**EPA Superfund
Explanation of Significant Difference
for the Record of Decision:**

**Bangor Naval Submarine Base,
Site A, Bangor, WA
7/18/1994**

**EXPLANATION OF SIGNIFICANT DIFFERENCES (ESD)
FOR SOIL AND GROUNDWATER REMEDIATION CHANGES
SITE A
SUBASE, BANGOR
BANGOR, WASHINGTON**

Site A Vicinity Map

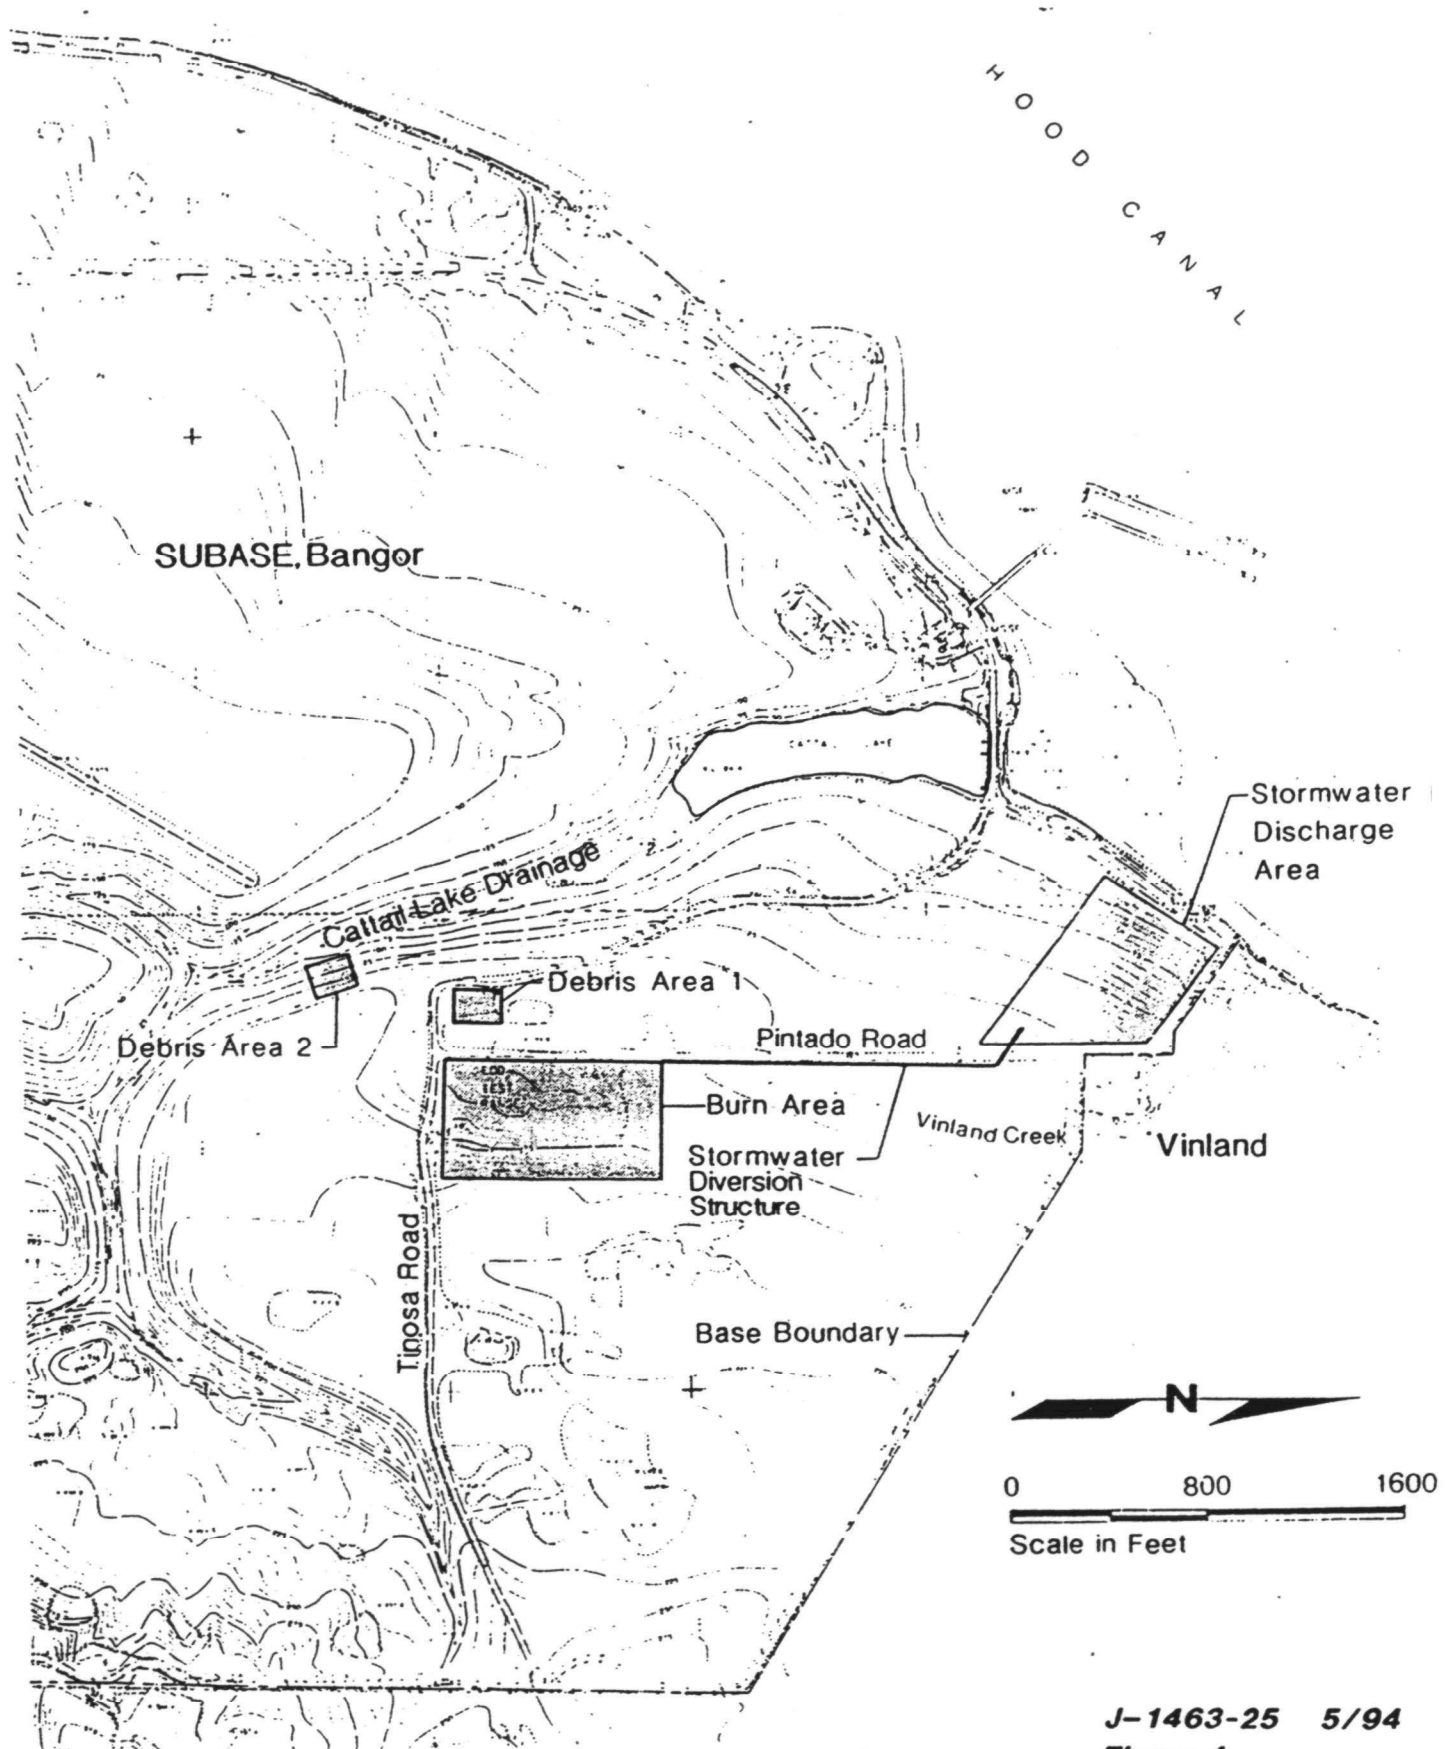
Debris Area 2 is located in a steeply sloping, heavily wooded drainage area containing significant undergrowth. The slope incline is estimated to be 0.75 horizontal to 1.0 vertical. A stream at the bottom of the slope flows into Cattail Lake, which is located approximately 100 yards further down the drainage (Figure 1). The Cattail Lake basin supports sensitive flora and fauna habitats.

- 2) **Soil Excavation on the Steeply Sloping Site May Impact Sensitive Habitats in the Cattail Lake Basin.** The Navy's RAC evaluated a range of strategies and technologies for excavating soil from Debris Area 2. All excavation strategies would require the removal of trees and undergrowth, which aid in stabilizing the slope, and considerable overexcavation for site access and equipment operation. The RAC concluded that these activities may cause destabilization of the slope, resulting in significant soil erosion both during the remedial activities and following such activities, until the slope restabilizes through revegetation. Soil erosion would likely impact sensitive habitats in the Cattail Lake basin.

Based on the above information, it is now proposed that the lead-contaminated soil at Debris Area 2 be left in place. Potential damage to sensitive habitat in the Cattail Lake basin may result due to soil erosion if soil excavation occurs. The volume of contaminated soil is relatively small, and the maximum contaminant (lead) concentration detected in that soil exceeds the cleanup standard by less than a factor of three. The contaminant is effectively bound to the soil, and therefore presents no significant risk to groundwater. The overall risk to human health and the environment associated with excavating the soil is judged to be greater than the risk associated with leaving the soil in place.

Institutional controls will be implemented to restrict future access to the Debris Area 2 slope. These controls will include a combination of barriers (e.g., fences, blackberry bushes, etc.) and warning signs. In addition, the SUBASE, Bangor, Master Plan will be revised to restrict future residential development in the vicinity of Debris Area 2.
